Key Revisions as requested by Winvic:

Delin,
California Drive,
Castleford

Drainage Layout
Sheet 1

Project - Originator - Zone - Level - Type - Role - Number	Status	Rev
P26014-BWB-EX-XX-DR-C-0501	A5	C03

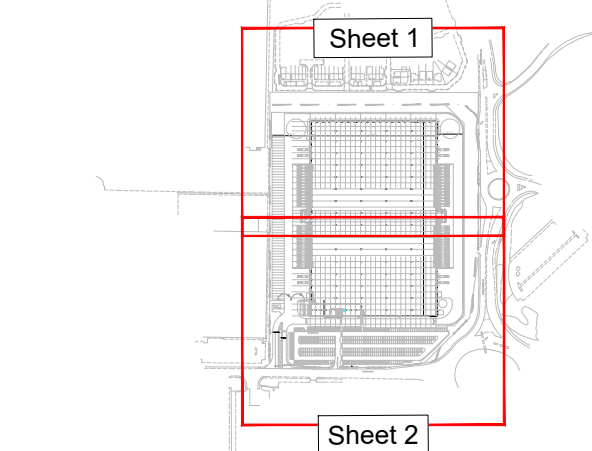
- Kerb drainage in service yard routes replaced with slot drains.
- Kerb drainage in the car park area replaced with linear drains.
- SW MH 41A added to avoid clash with retaining wall foundation.

- Manhole invert levels, cover levels etc to accommodate Winvic amendments (clouded).
- Foul drainage route in South Service yard road realigned to accommodate slot drains (clouded).
- Land drainage added to back of king post retaining wall; soakaways added at end of land drain runs (high points shown).
